Appendix B

Responses to NRC Questions

Page
Responses to Questions on GESTAR II Revision 5	US.B-3
Responses to Questions on the Barrier Fuel Amendment (Amendment 6)	US.B-113
Responses to GESSAR II Questions Regarding SRP Section 4.2	US.B-120
Responses To Questions On The Fuel Loading Error Analysis (Amendment 28)	US.B-126
Responses to Questions on Additional Amendments (References)	US.B-136

Figure 4A. Fuel Bundle – Support Hydraulic Modeling

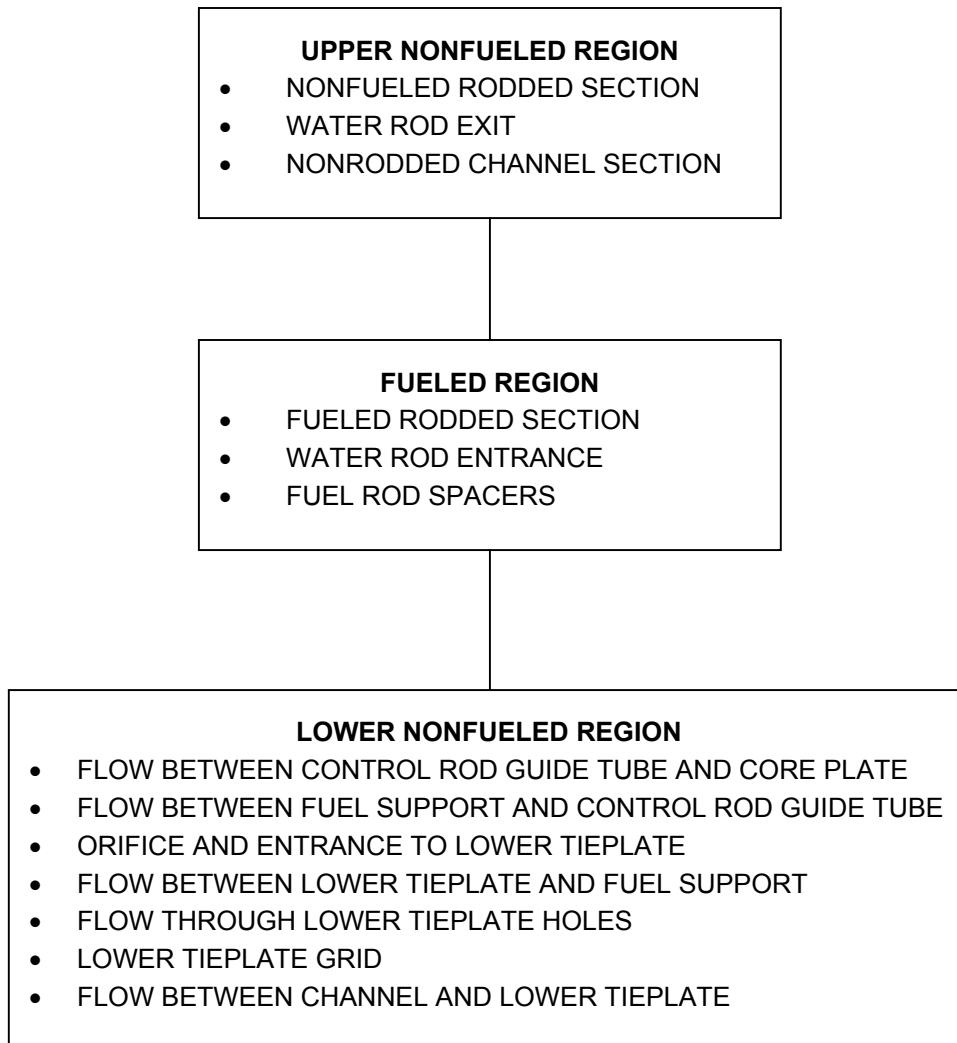
The fuel bundle and fuel support assembly consists of three basic regions as illustrated in Figure 4A. Figure 4-1 of the report is a schematic showing the features of the lower nonfuel region. During normal operation, this region is characterized by single phase flow. A pressure drop is calculated across the orifice and entrance to the lower tieplate, which includes friction, an irreversible loss due to area change, and a reversible pressure drop due to an area change. Flow through the lower tieplate holes and through the lower tieplate fuel support paths is calculated and subtracted from the flow through the fuel support orifice. The remaining flow passes through the lower tieplate grid, experiencing additional reversible and irreversible pressure changes. The flow through the channel lower tieplate path is calculated and subtracted from the lower tieplate grid flow. Flow through the water rods is also subtracted, as will be discussed separately.

The General Electric Company has taken a significant amount of single- and two-phase pressure drop data in full scale geometries representative of 7x7, 8x8 and 8x8R fuel and correlated the two-phase multipliers on a best fit using the two-phase models reported in References 4-4 and 4-5 in conjunction with the void fraction model. The typical test conditions (Table 4B) are representative of BWR operating ranges. Figure 4A demonstrates the applicability of these models.

Figure 5.1.1-1a. Relative Bundle Power Histogram for Power Distribution Used in Statistical Analysis for BWR/4 8x8R Reload Core

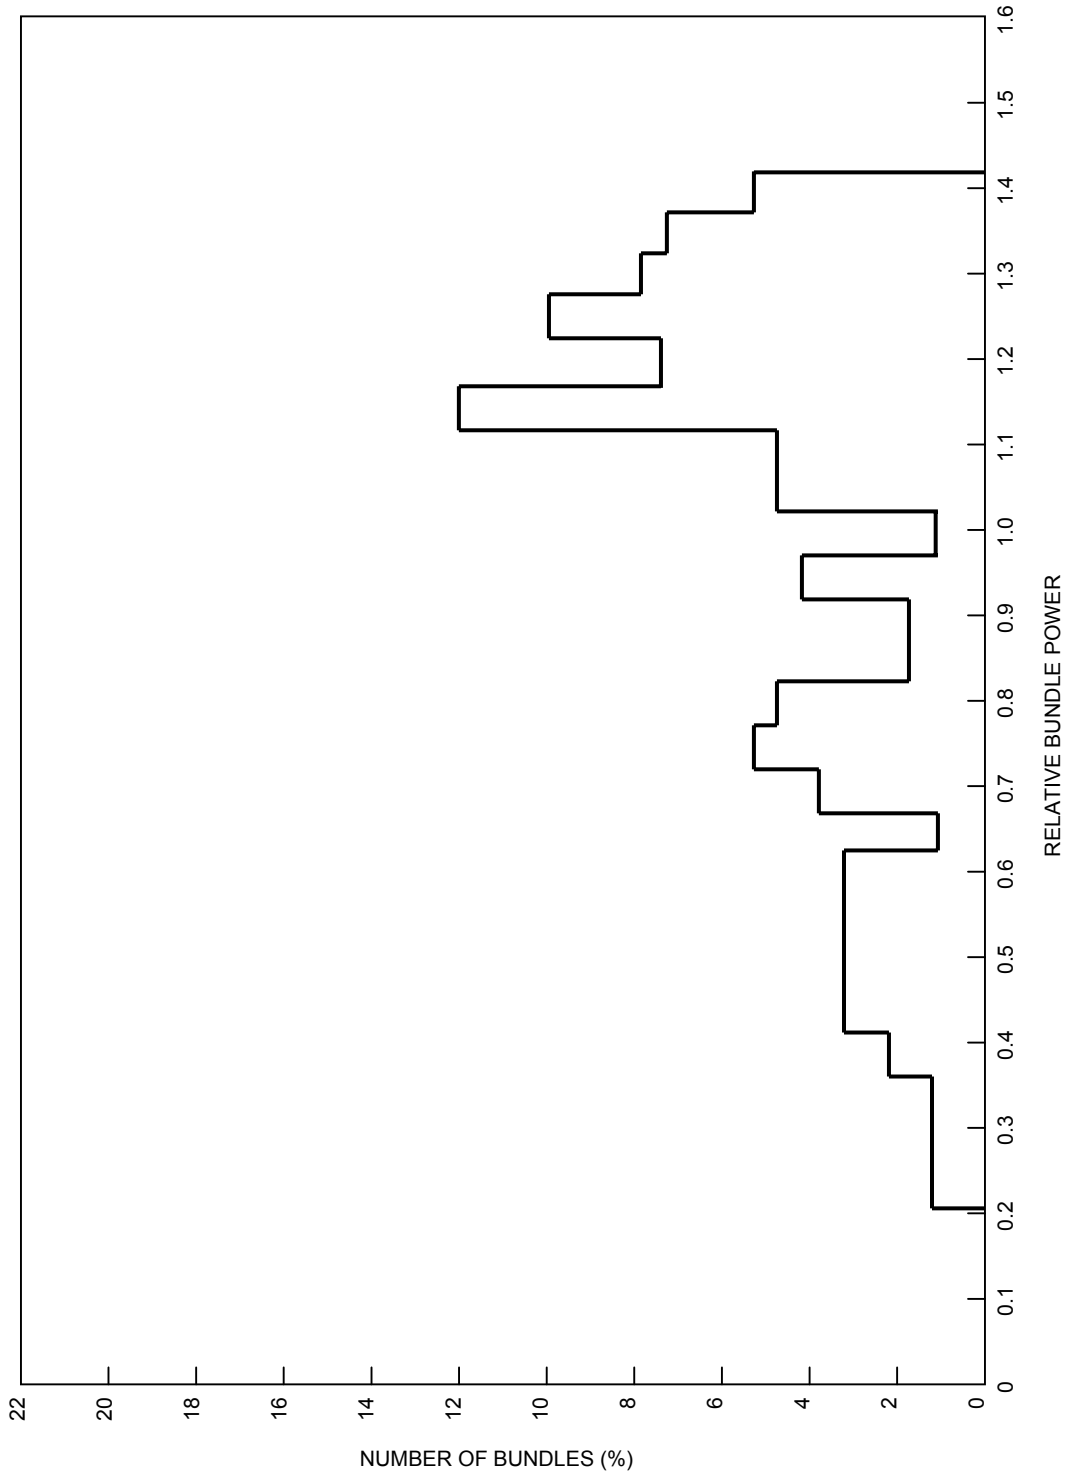
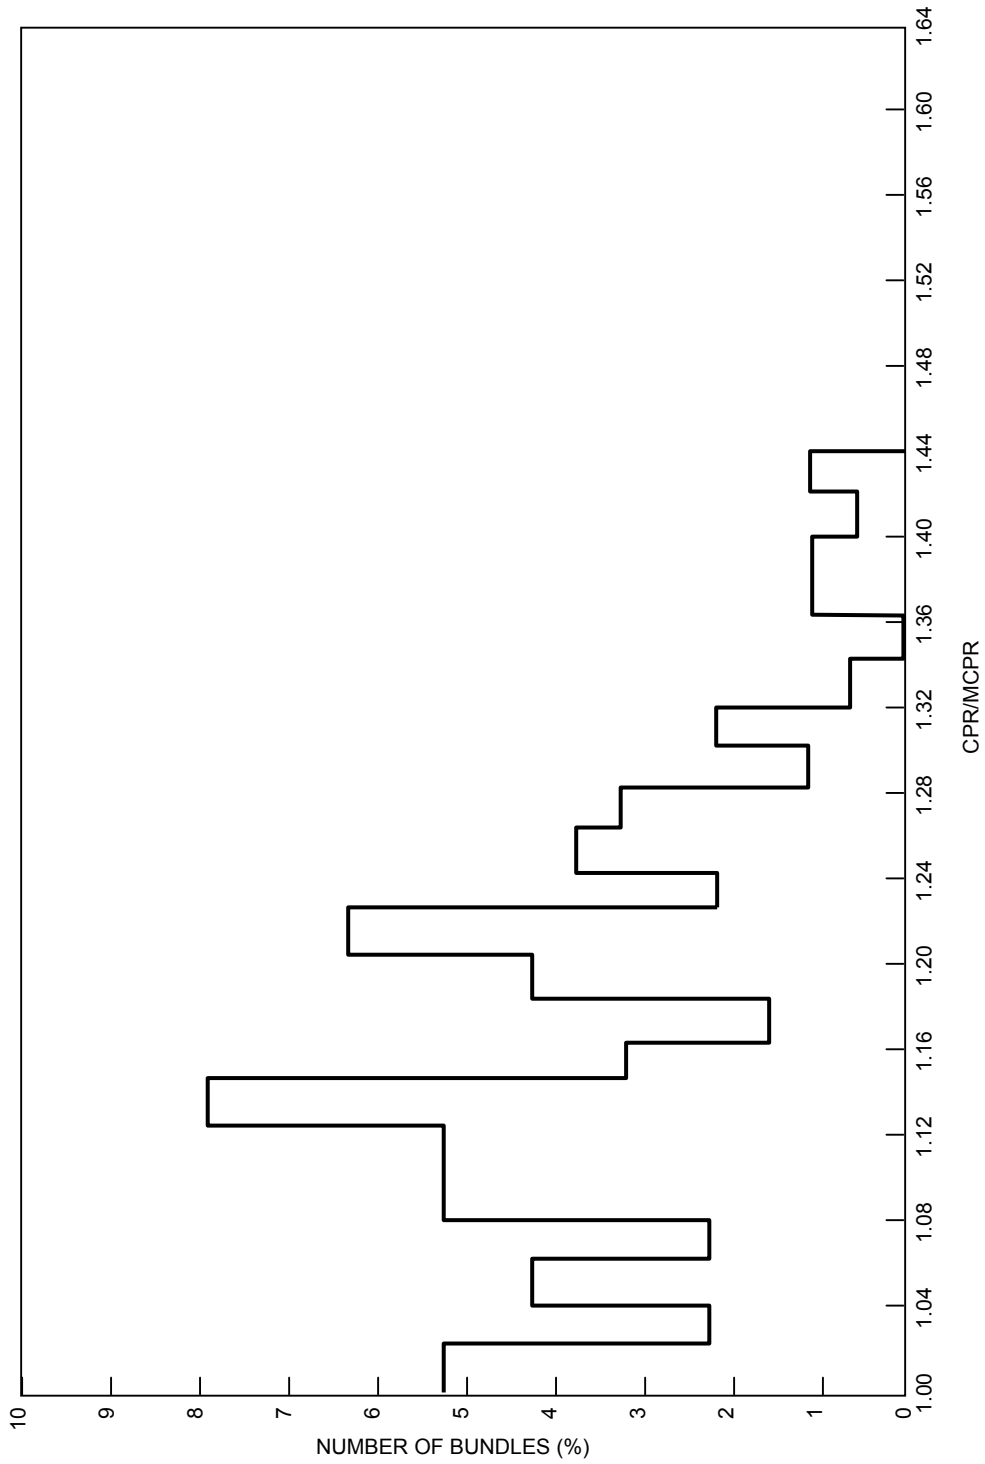
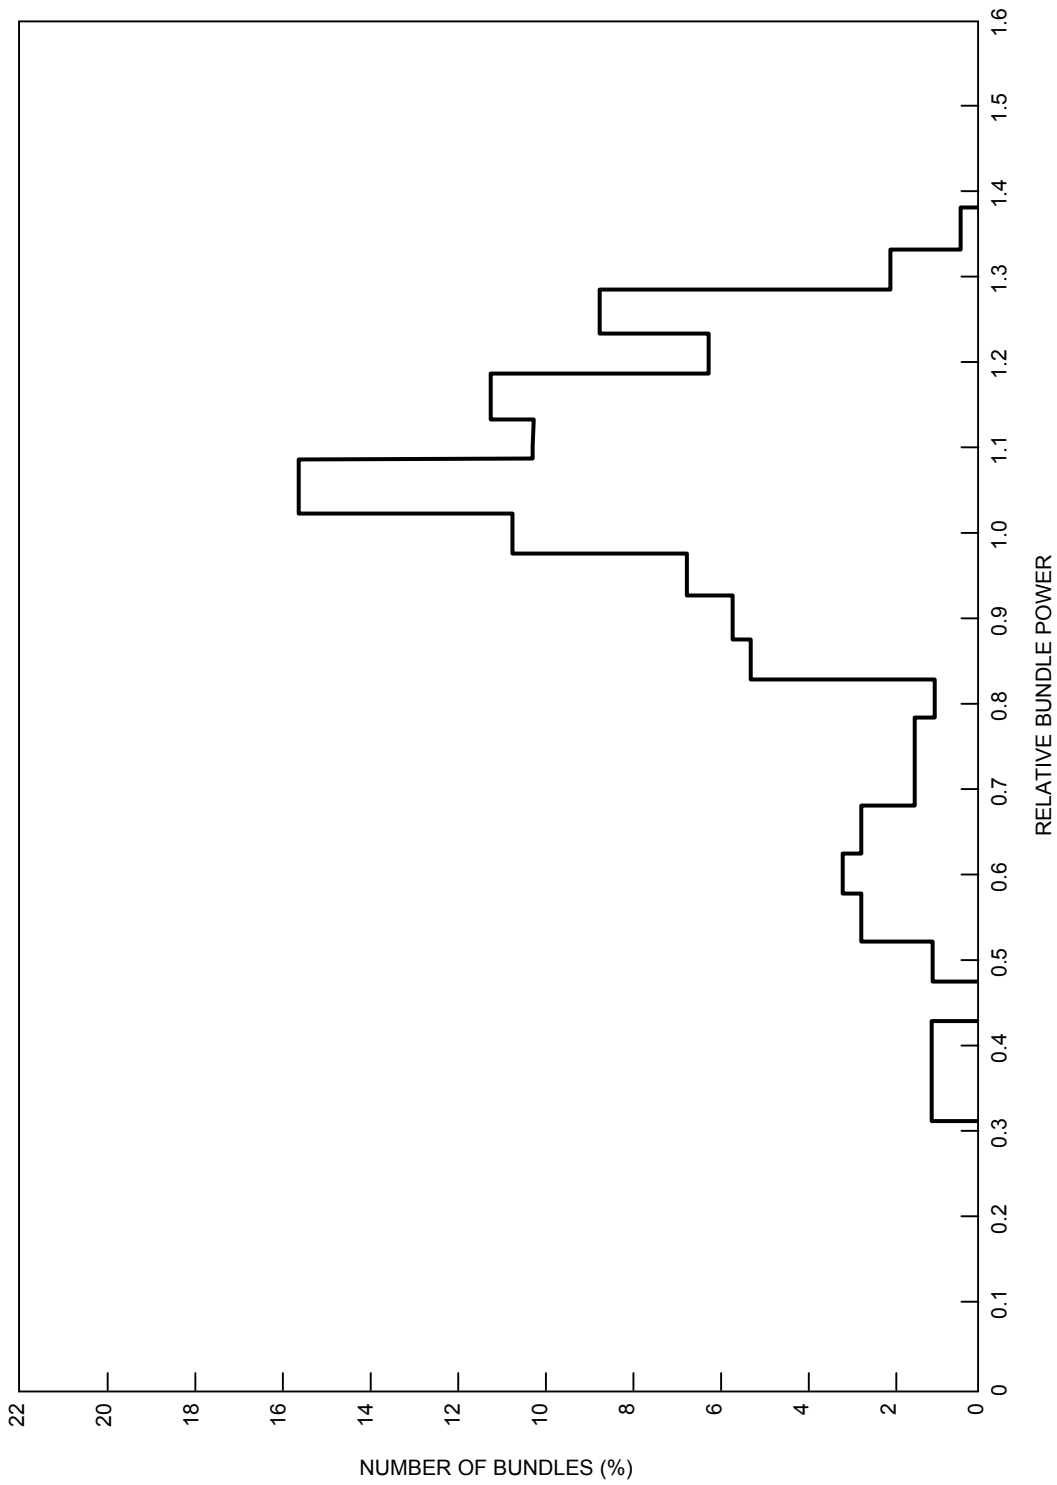
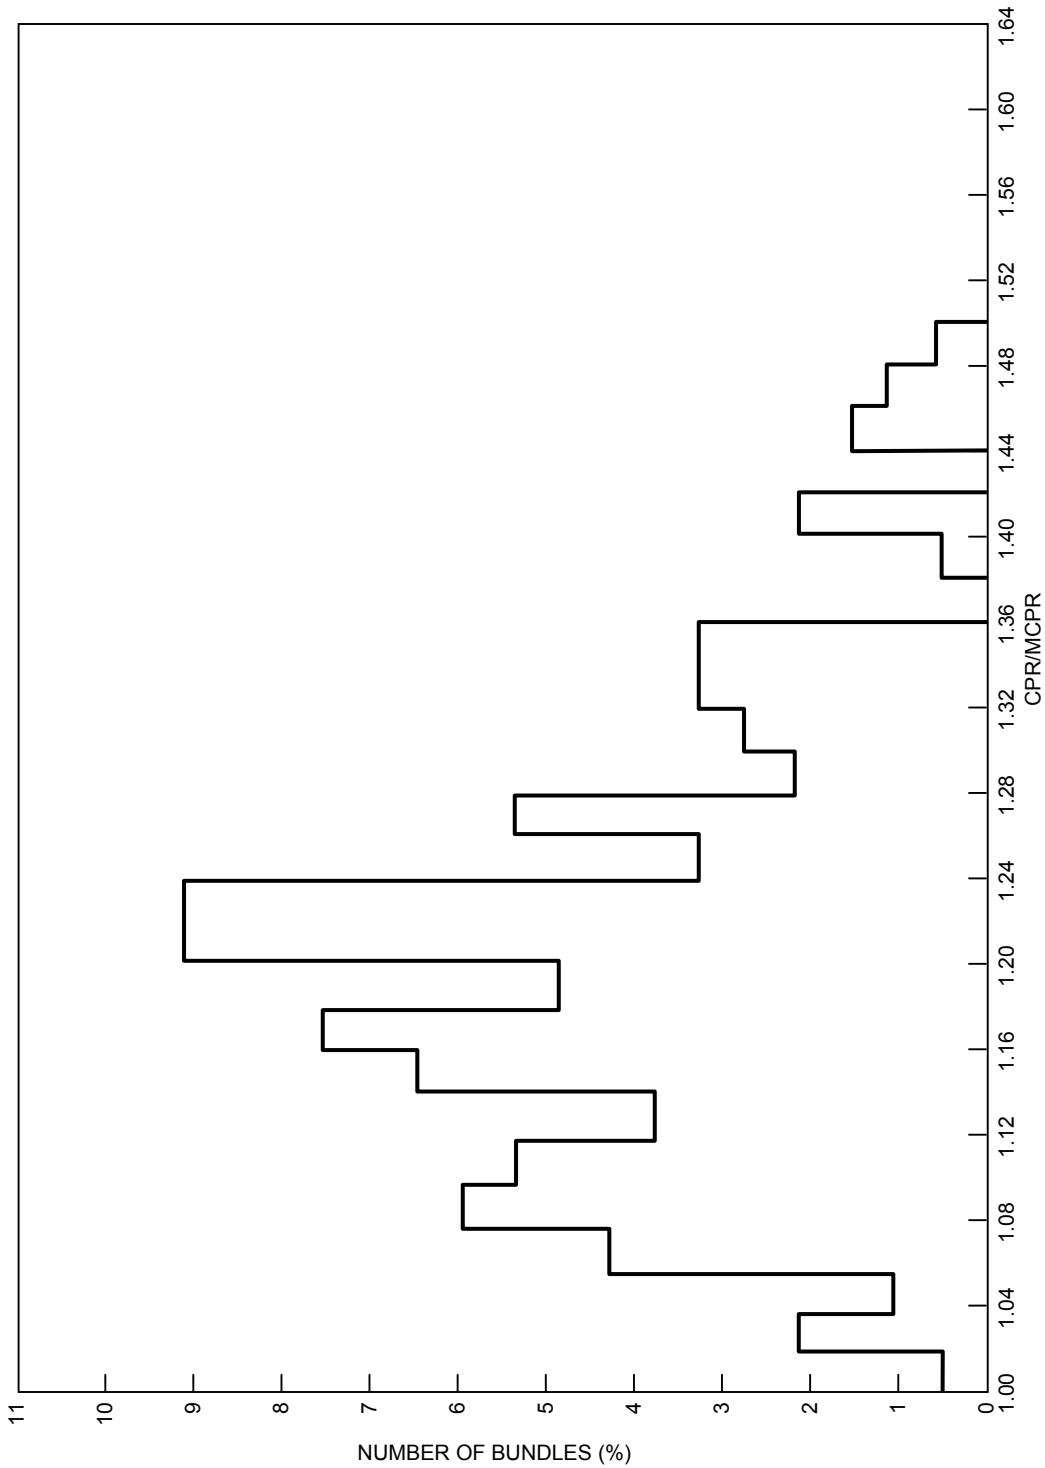
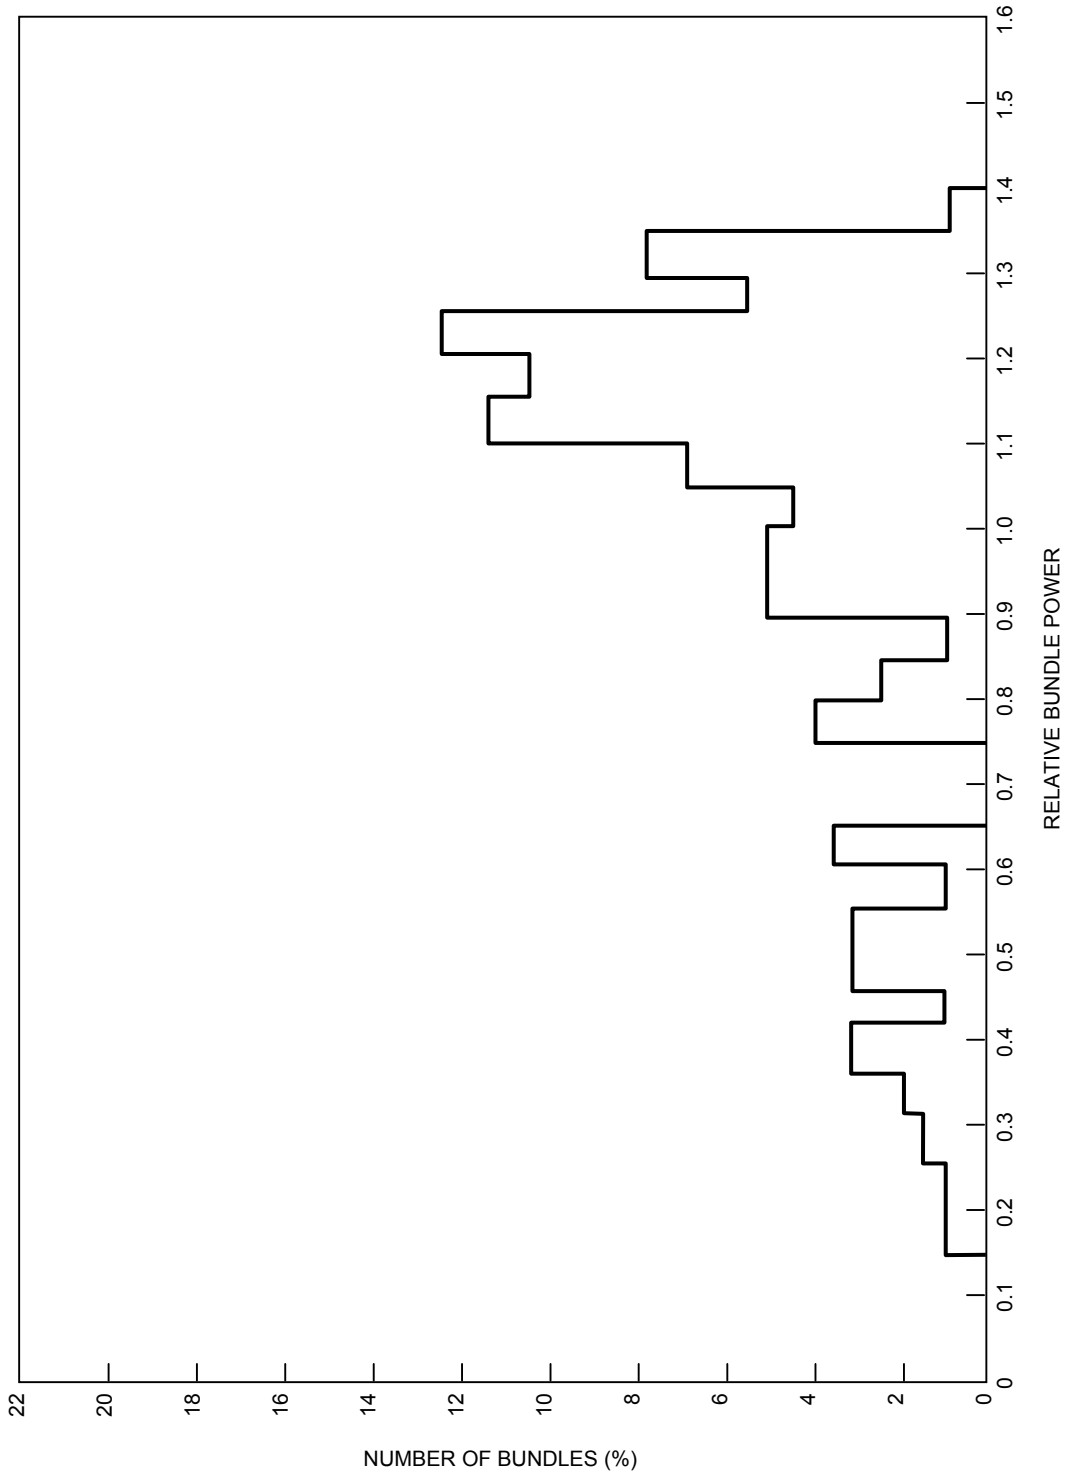
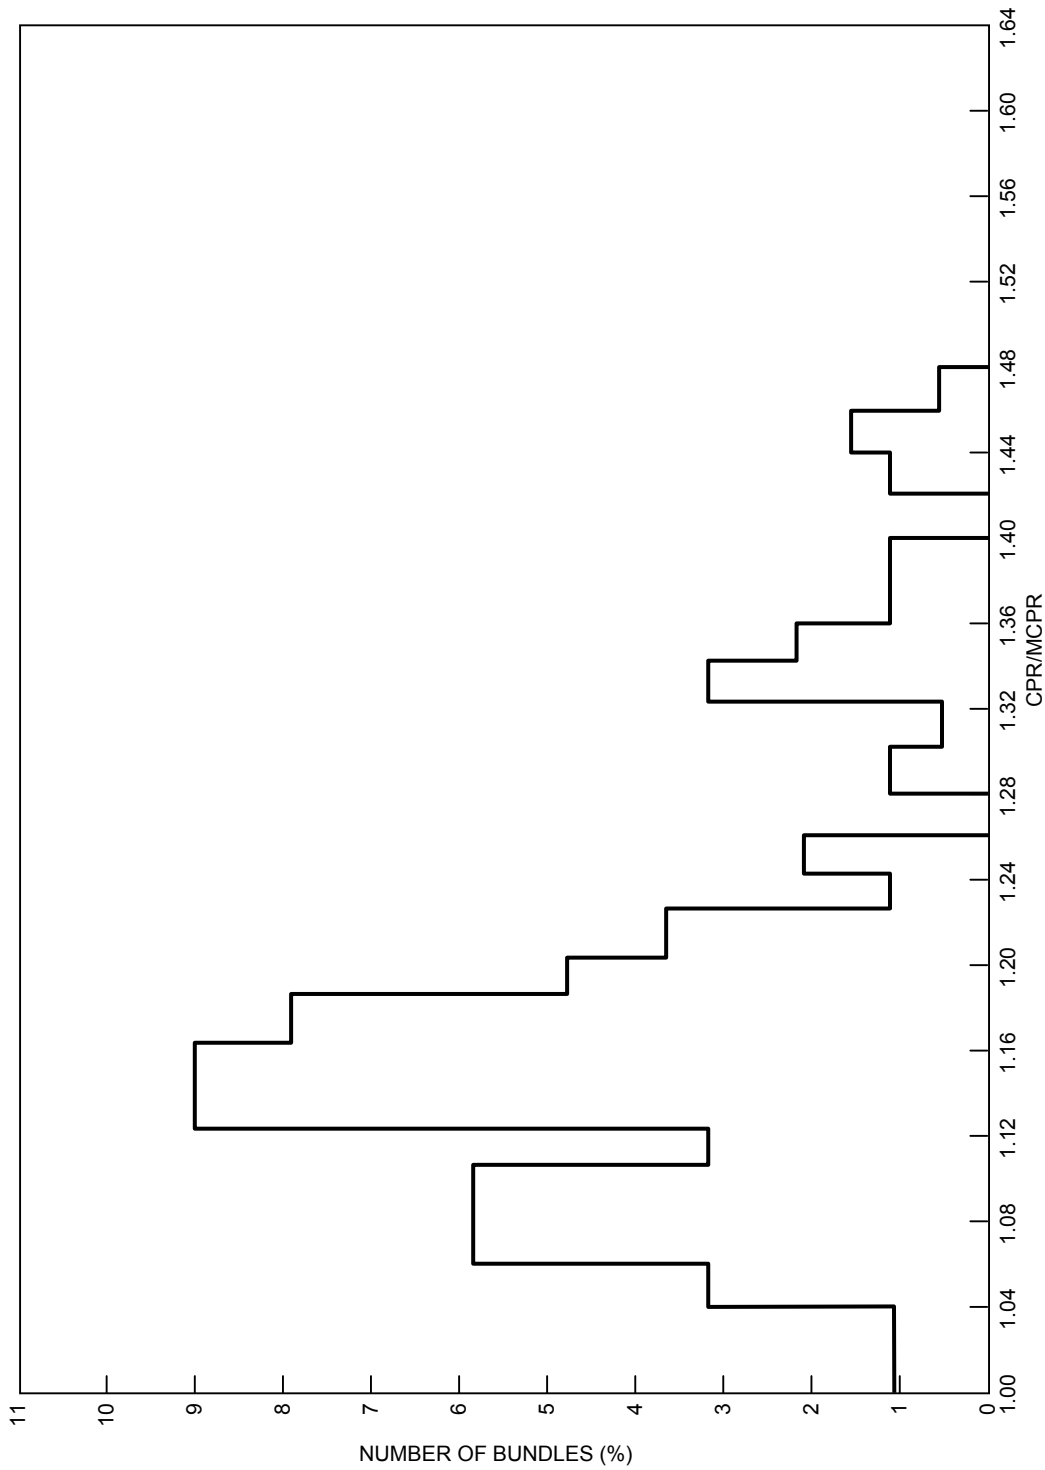
The design basis CPR and relative bundle power histograms for the 8x8R reload core (Figure 1) are compared with two sets of operating histograms (Figures 2 and 3). The operating histograms include the histograms representing both severe and typical of those expected at the BWR/4 8x8R reload core when the reactor is operated at rated core power with the most limiting bundle close to the MCPR operating limit. As can be seen, the expected operating distributions are much more peaked than the ones assumed in the licensing basis, thus yielding an expected operating 99.9% statistical limit MCPR of approximately 1.01 to 1.03. This example illustrates the degree of conservatism included in the licensing basis safety limit MCPR.
